## DISTRICT OF WEST VANCOUVER

# COUNCIL REPORT

Date: September 12, 2013 File: 1010-20-12-084  
From: Lisa Berg, Senior Community Planner  
Subject: **Official Community Plan Amendment, Rezoning and Development Permit No. 12-084 for 825 Taylor Way and 707 Keith Road (Maison Seniors' Living)**

# SECTIONS - LOOKING NORTH

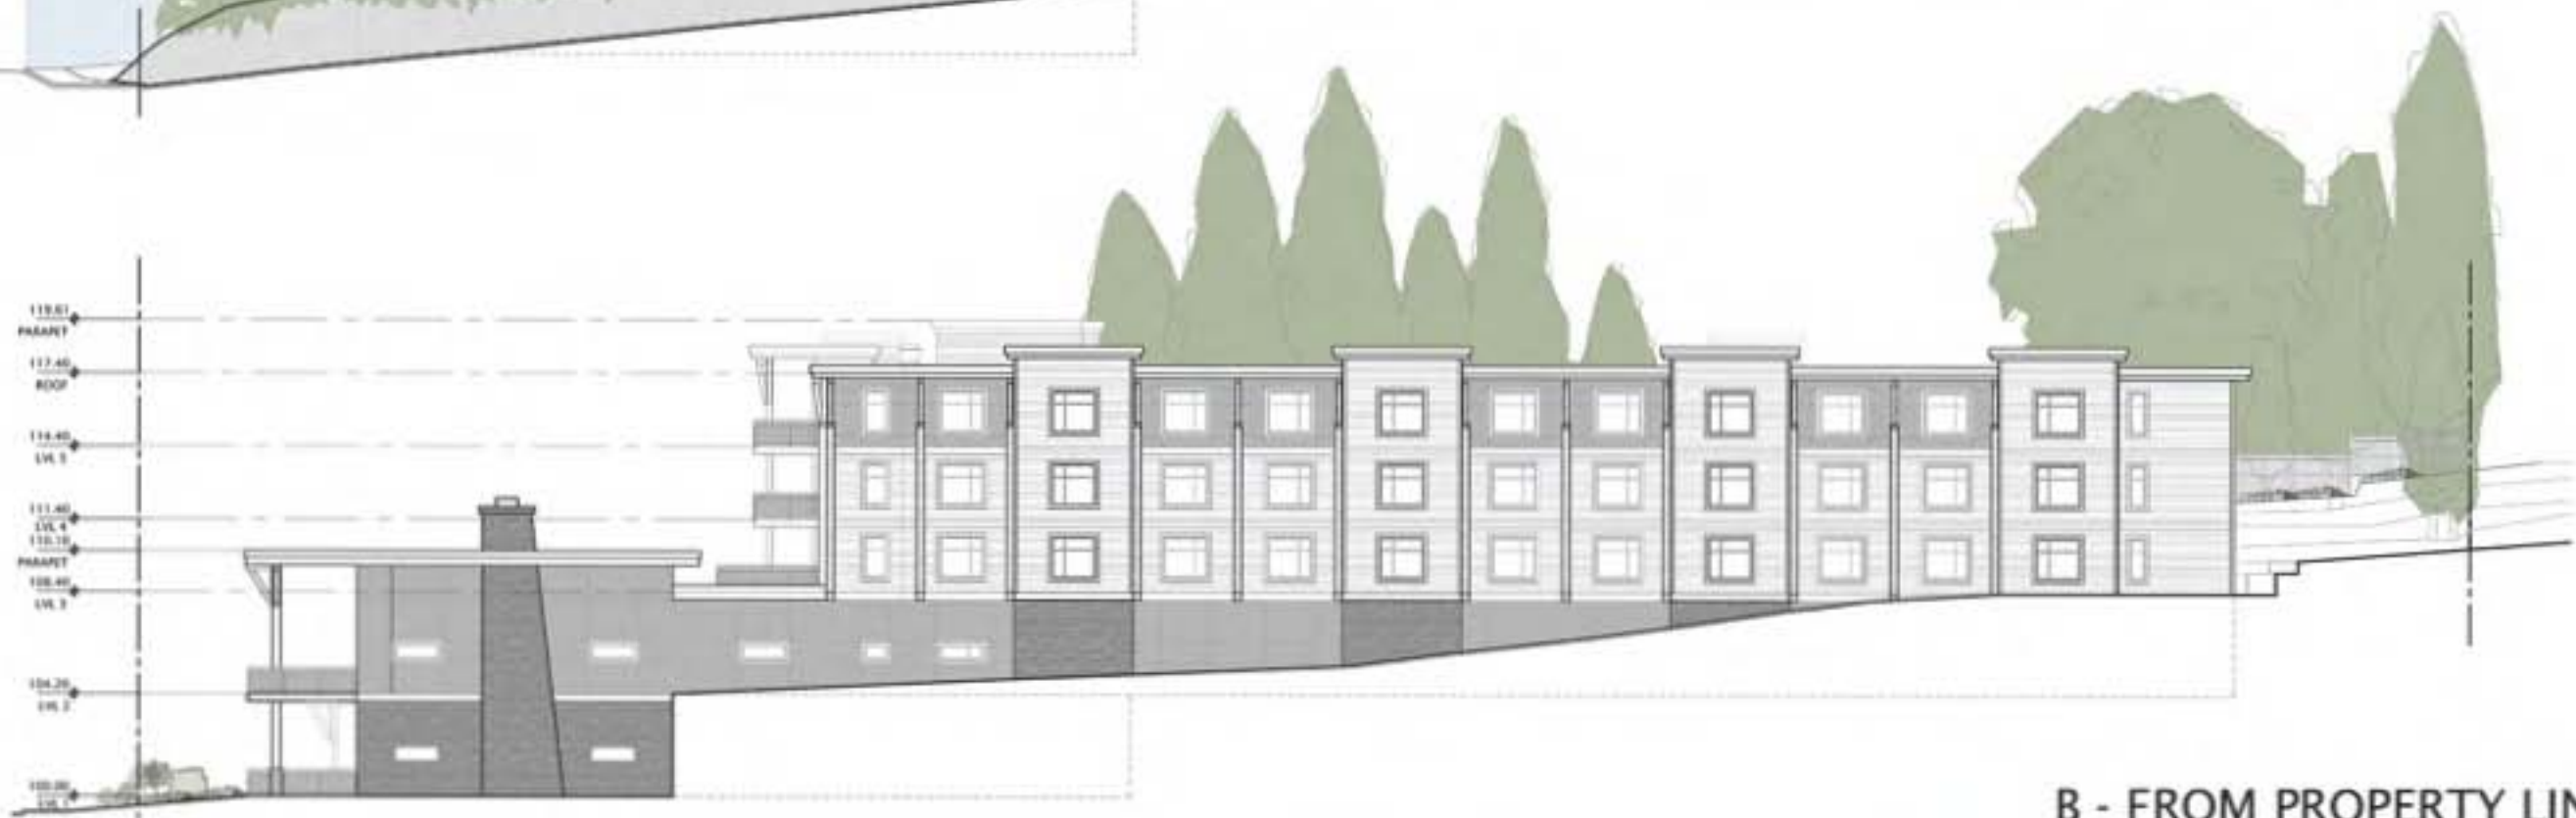
11. In terms of context, why are adjacent homes not shown on the model or drawings to understand massing relationship? *Model started out as study model and evolved into detail model. Have not been able to be on the property to measure the properties so at a disadvantage.*

- Think the use is well-suited to this location (i.e., a busy intersection on a major arterial route). Context - don't understand from the presentation the context; more work needs to be done. I understand lack of access to adjacent properties, but it is your issue to figure out. Think parking will be an issue, as there is no immediate street parking for visitors, important in moving forward to make sure whatever evidence have supports this number of parking spaces is not anecdotal; needs to be imperial in order to make sense.
